### APPEAL SUMMARY

**Appeal ID:** 20803

**Project Address:** 2345 N Ross Ave

**Proposed use:** Private Recording Studio & Storage

2 LEVEL 1 - CODE PLAN  
1/16" = 1'-0"

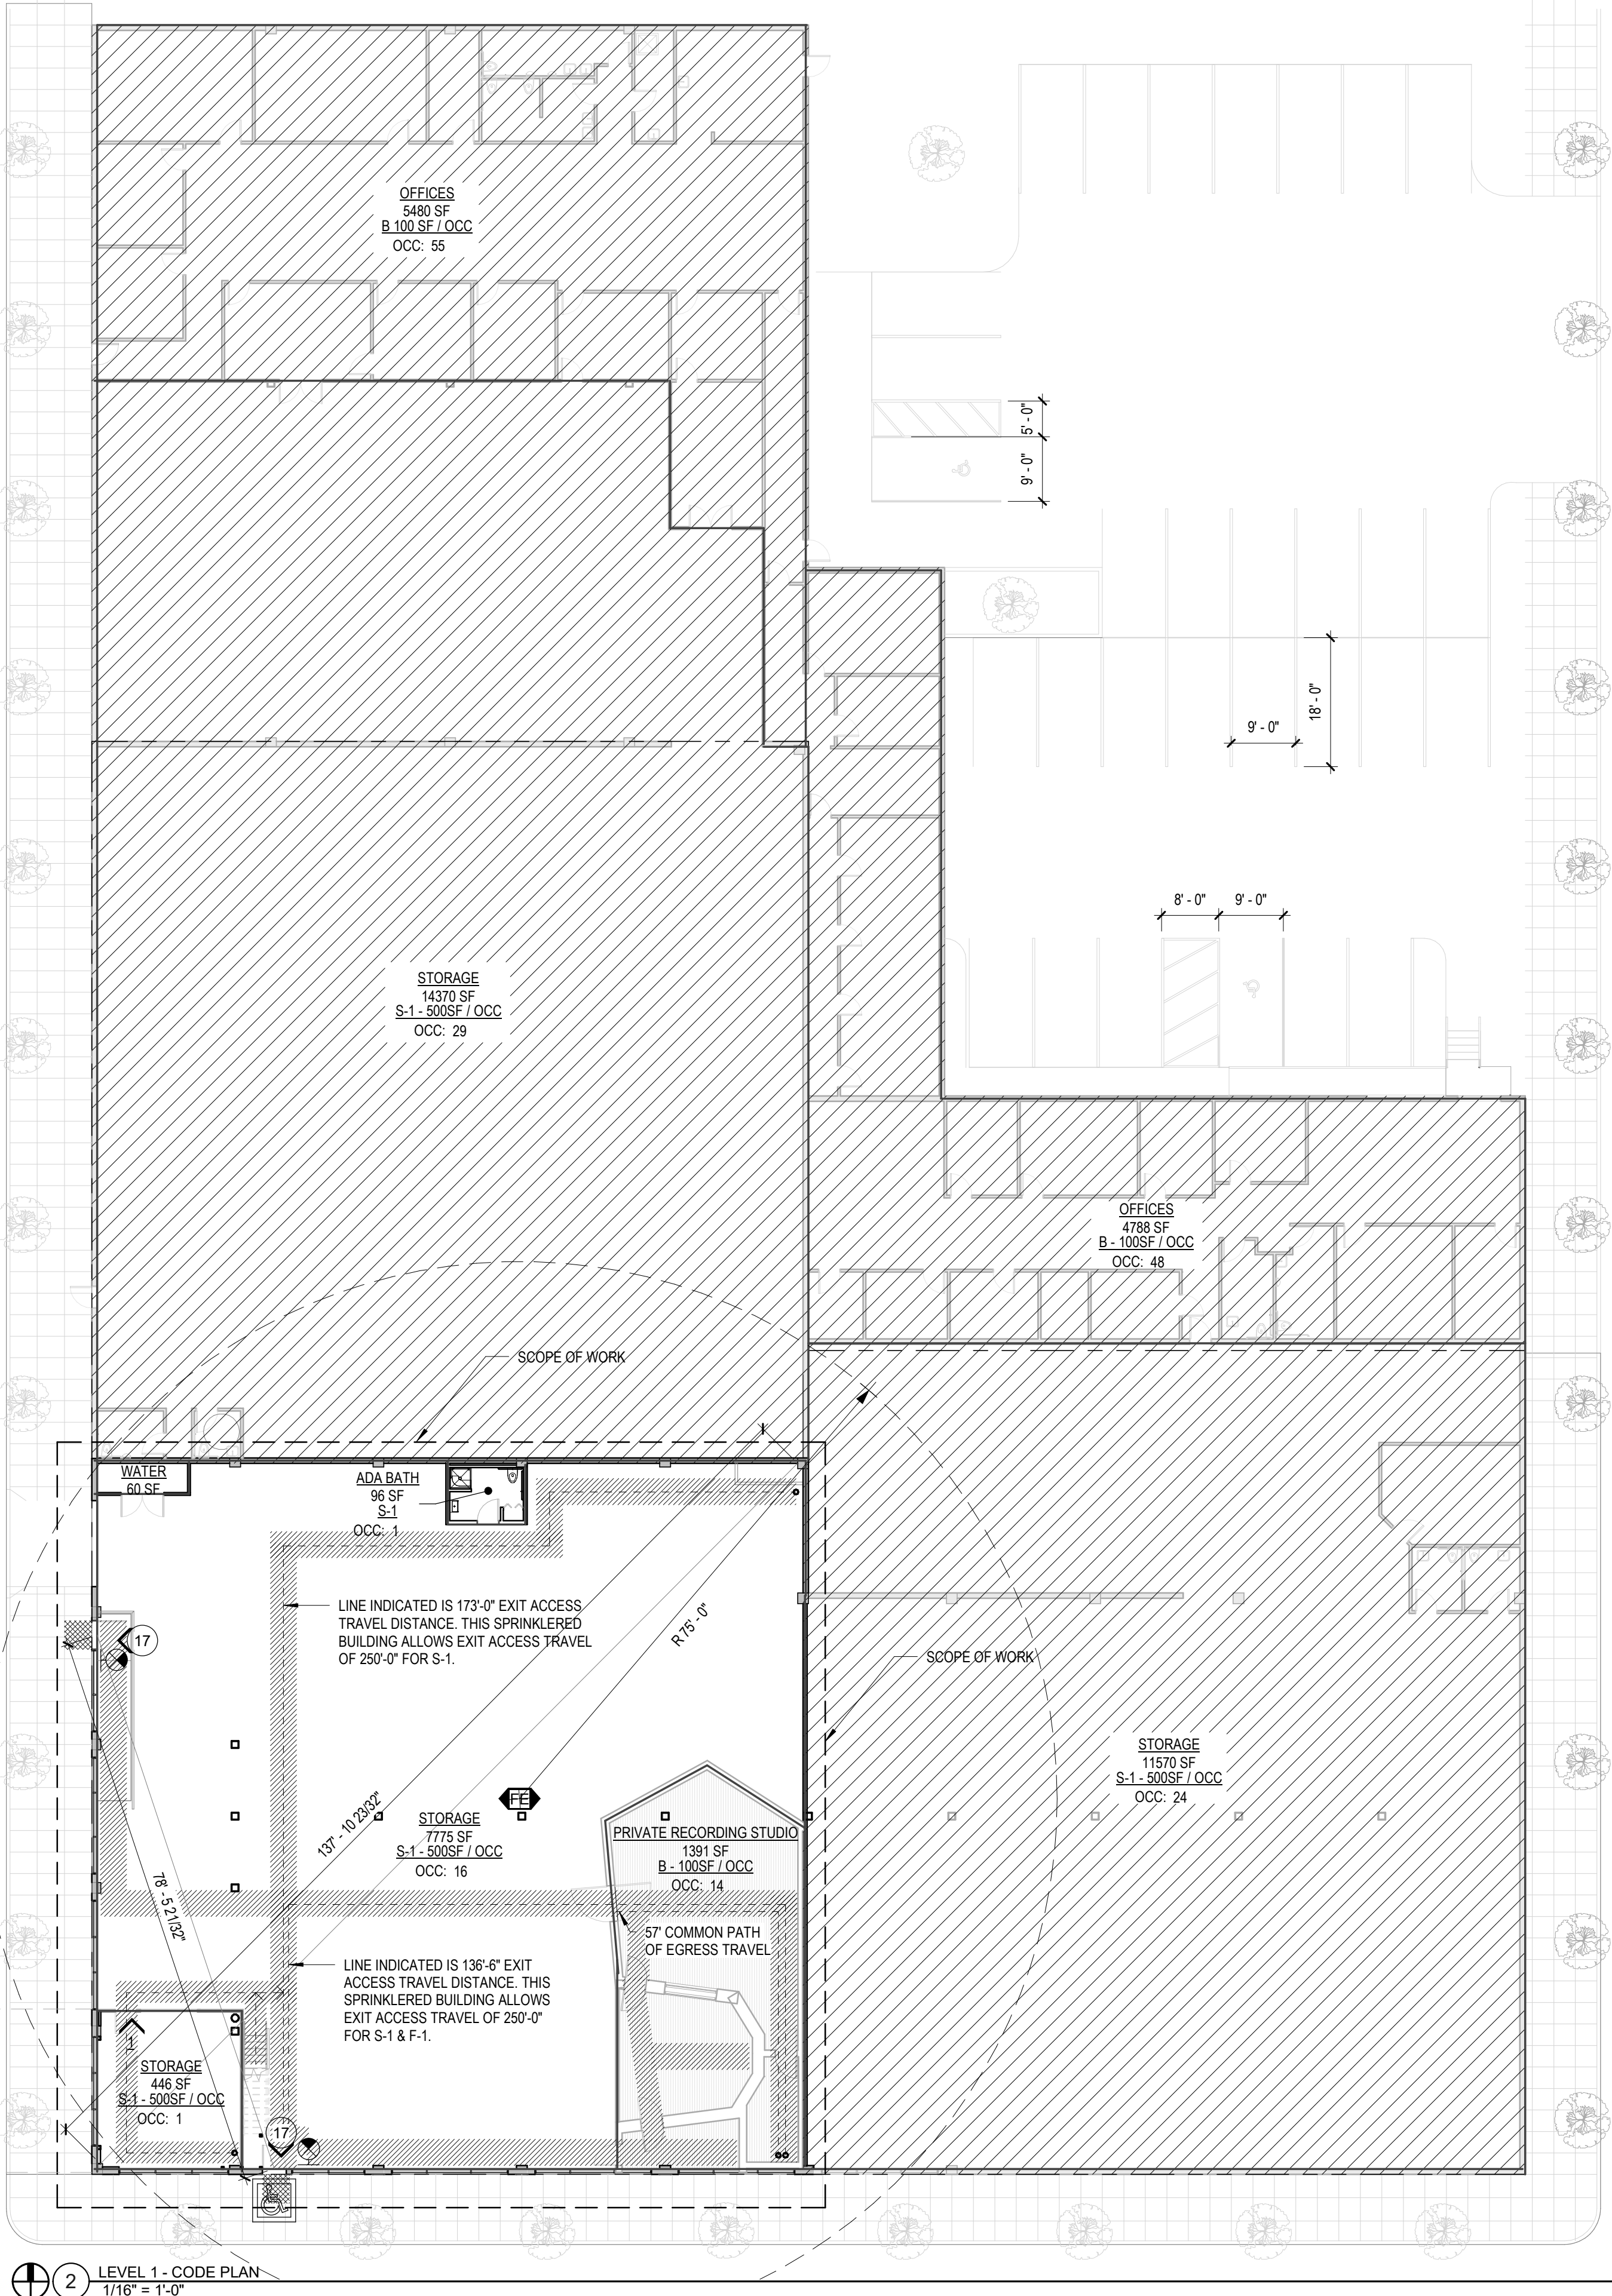
This building has (3) existing bathroom clusters with separate facilities for Mens and Womens use, in addition to the unisex bath we are adding. These existing toilet facilities are available and accessible to occupants of our space. The plumbing fixture calculation for the building is provided on G002. The actual use of the space is private with only (3) people having key access. The tabular occupant load being applied to our space is not accurate for how it is proposed to be specifically used.

We request consideration of 2902.2 (as Amended on April 1, 2015), exception 2, which does not require separate facilities for spaces with occupancy less than 30 for the following two reasons:

The building already has separate plumbing facilities, exceeding tabular plumbing requirements -and-

Considering our proposed use, with actual occupant loads much less than 30, a single uni-sex ADA bathroom is sufficient for the space.

**3a. Toilet room access requiring travel through storage room: Granted as proposed.**

**3b. Omission of separate faciities with one single user toilet room: Granted as proposed for this tenant and use.**

A101

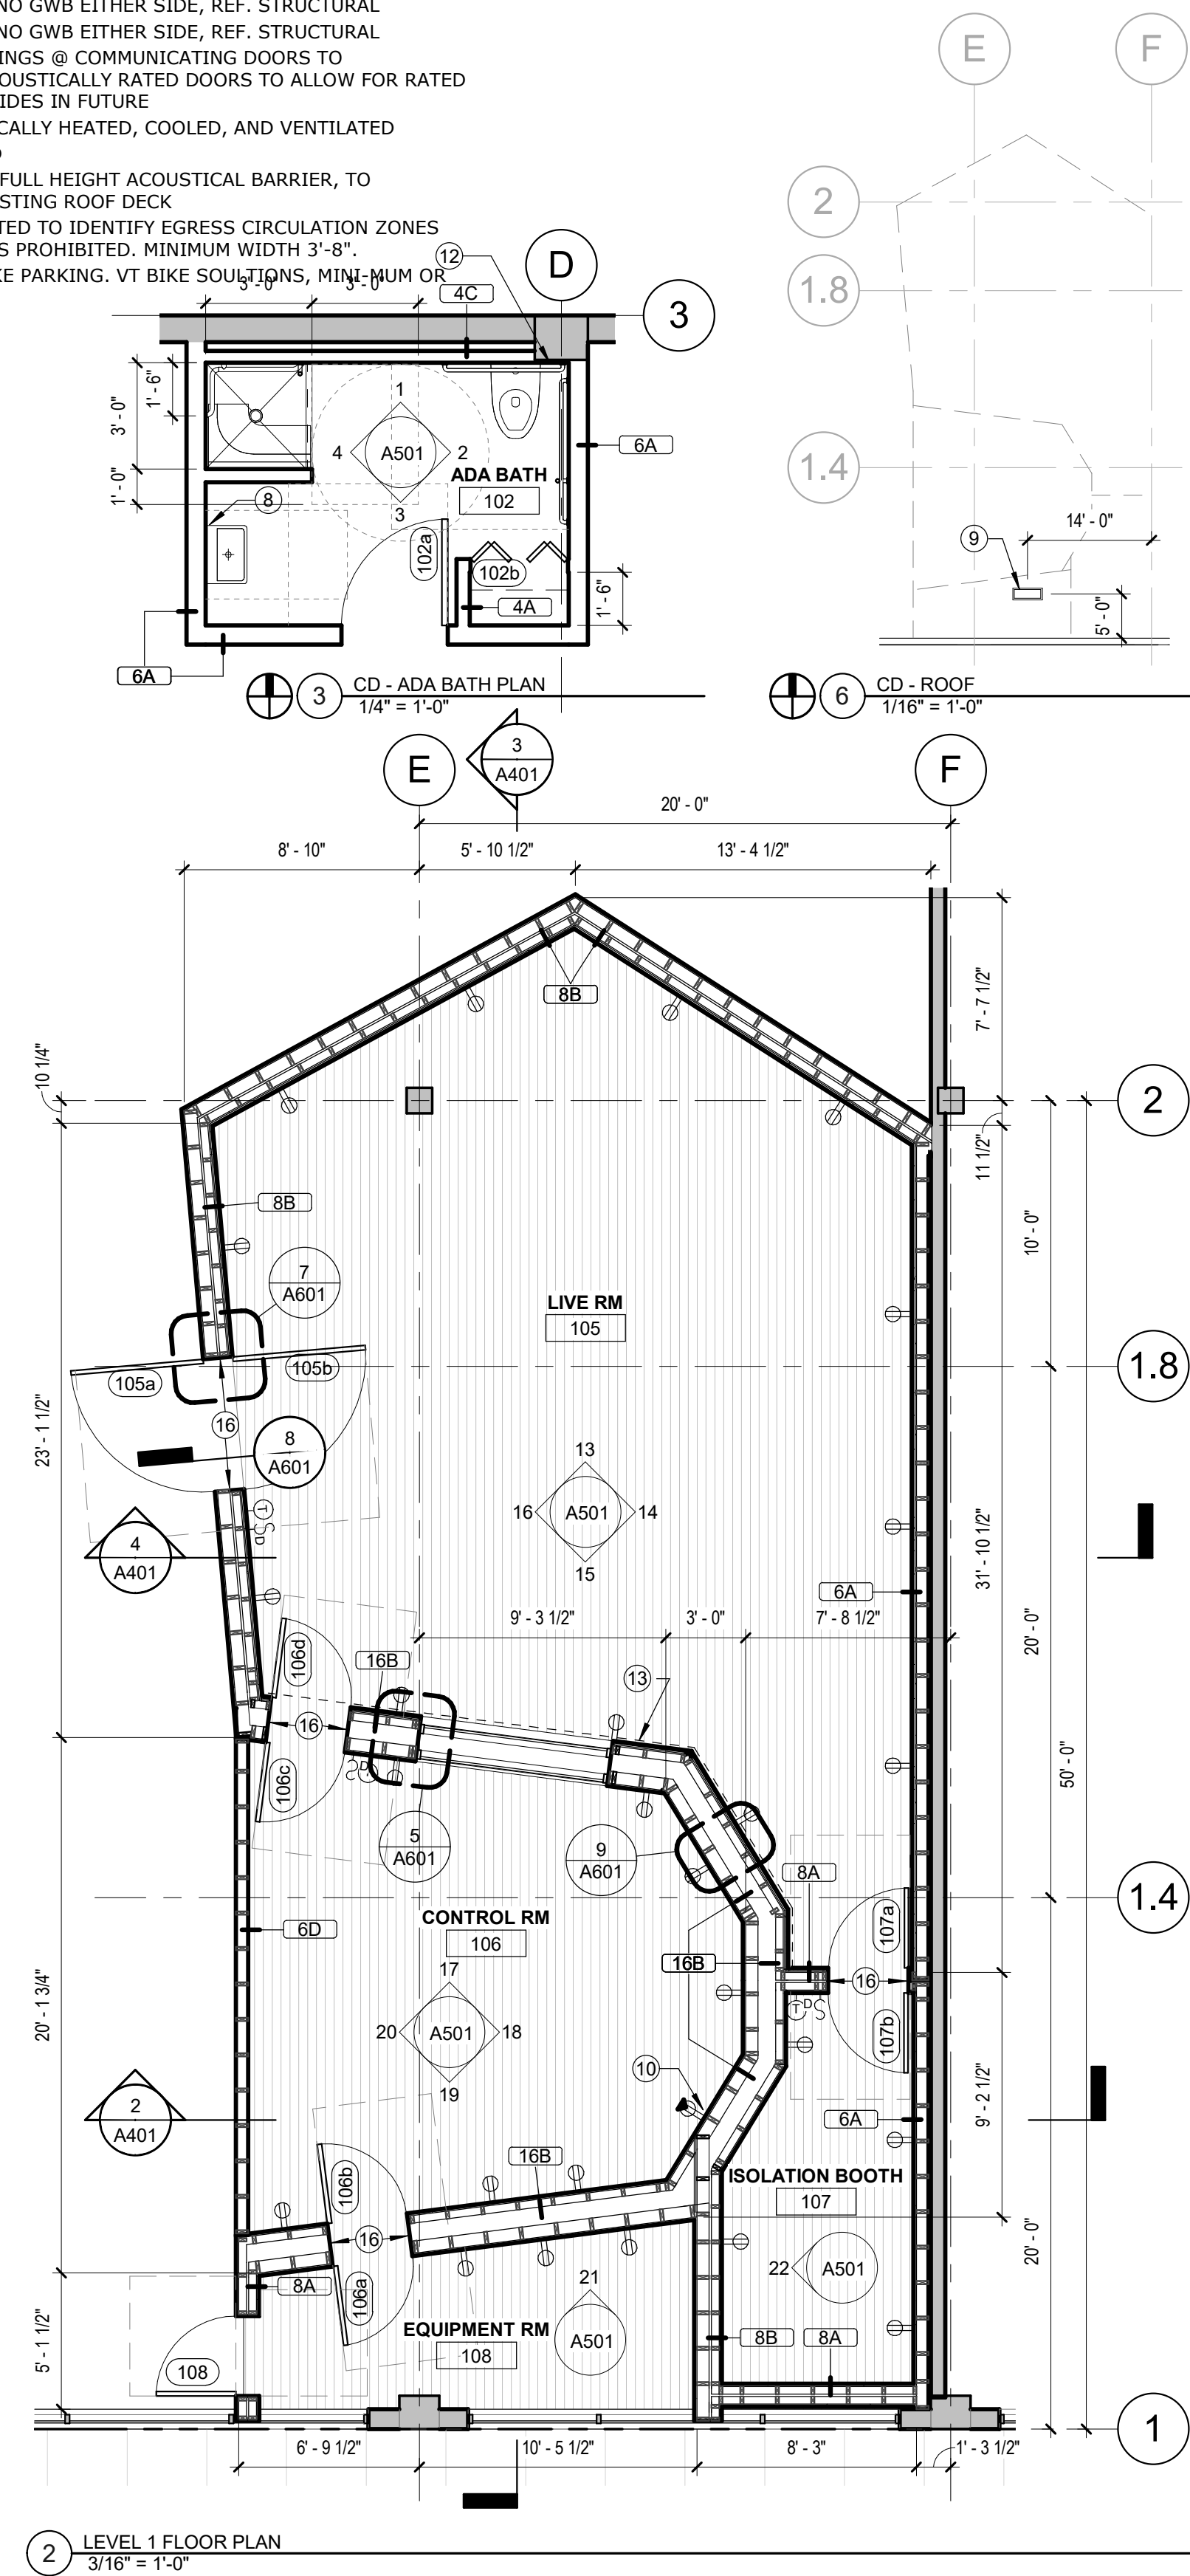
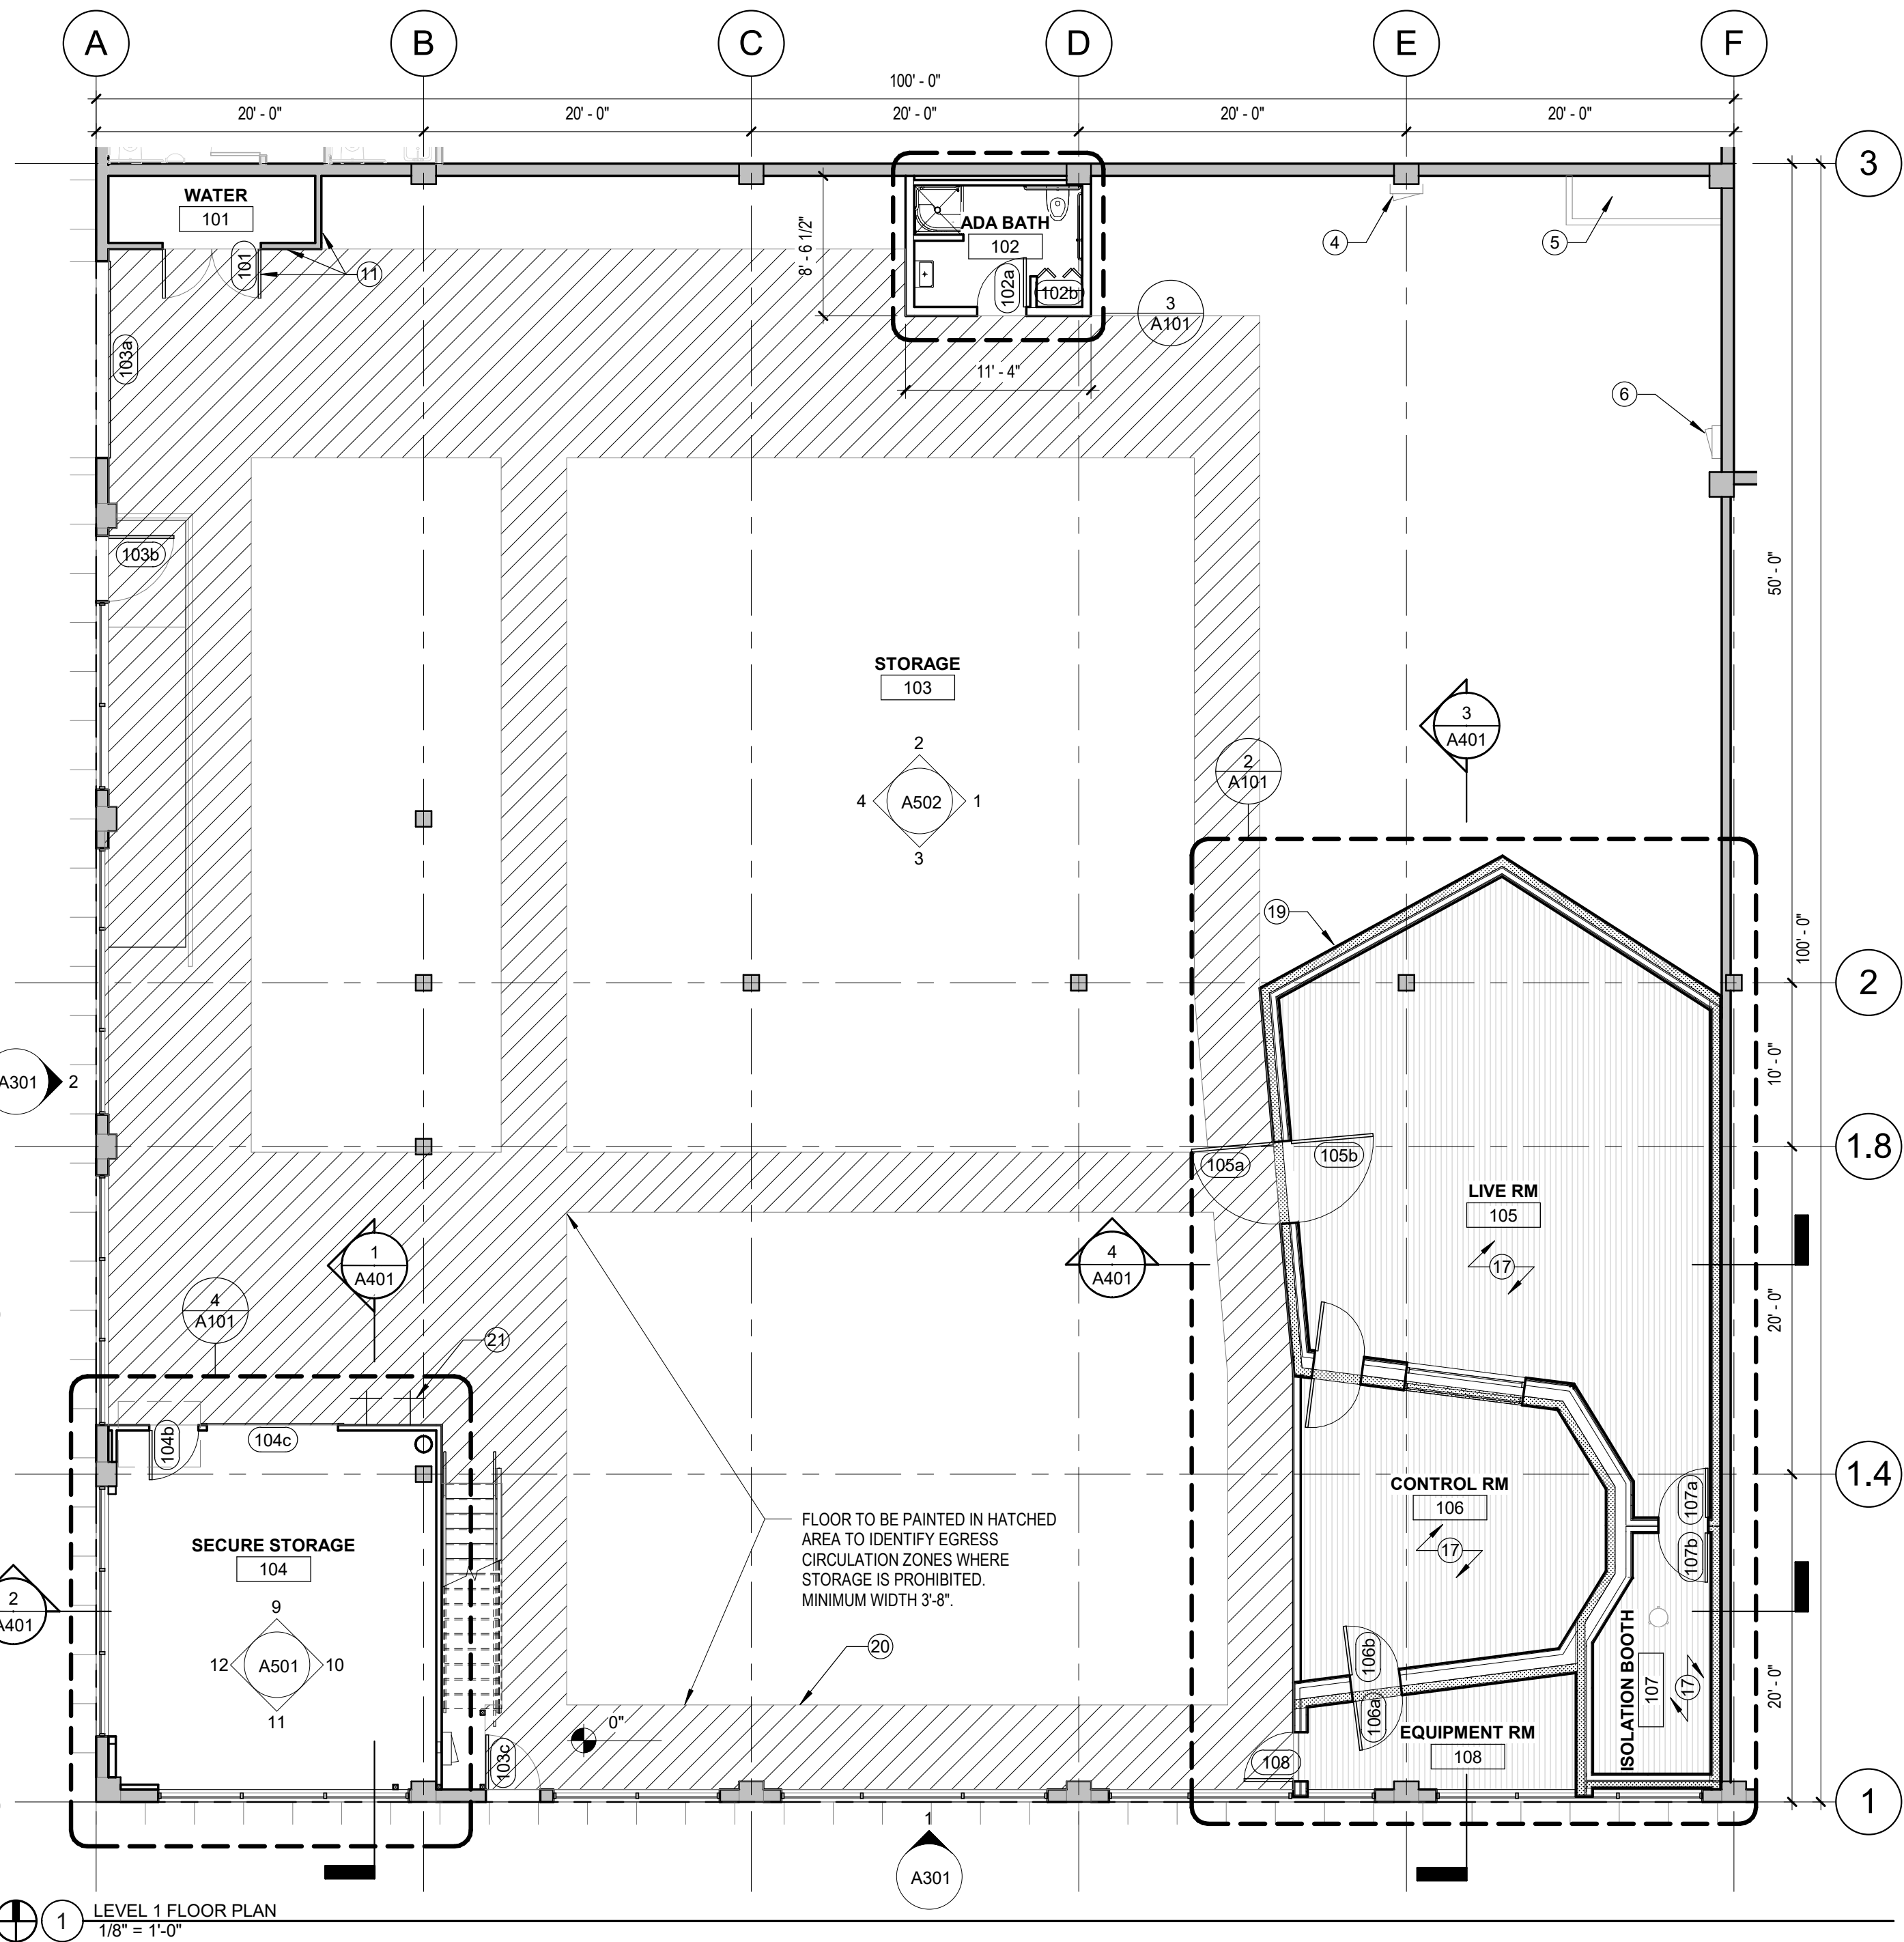
**Proposed Design** The actual use of the space is private with only (3) people having key access. We anticipate well below the tabular occupant load with the specific use proposed, and well below the volume of storage that a commercial storage use might see, since it is private family storage. With the low storage utilization of the space, we propose to add painting on the floor to demarcate egress circulation areas where storage will not be allowed. The use of these pathways will be for circulation only. Refer to attached Floor Plan for hatched areas indicating proposed egress circulation zones.

**Reason for alternative** By demarcating egress zones, the space will have a clear system to ensure required egress pathways are maintained. It was suggested in the FLS checksheet 19-173571-CO to request approval of the specific proposed configuration.

**Proposed Design** These door openings are located in an acoustical double wall, and not in a series of walls as separate openings. Our intent is not to create a habitable space between the communicating

doors, the doors are separated only for acoustical isolation. From either side of the wall, the hardware of either door is within ADA forward reach range, per ANSI A117.1, 308.3.2 (b) which allows a reach of 24" under 46" height. Assistance will be arranged for any persons who need any help at all communicating doors.

**Reason for alternative** Since the doors are still close together that the hardware meets reach range, and assistance will be arranged otherwise, we believe equivalent accessibility is provided. This appeal was suggested in the fls checksheet 19-123426-000-00-co to request approval of this door configuration.

**1. Egress through intervening storage space: Denied. Proposal does not provide equivalent Life Safety protection.**

**2. Doors in series with omission of 60 inch clear space: Granted provided automatic door openers are provided to allow accessible entry to Live Room, Control Room and Isolation room.**
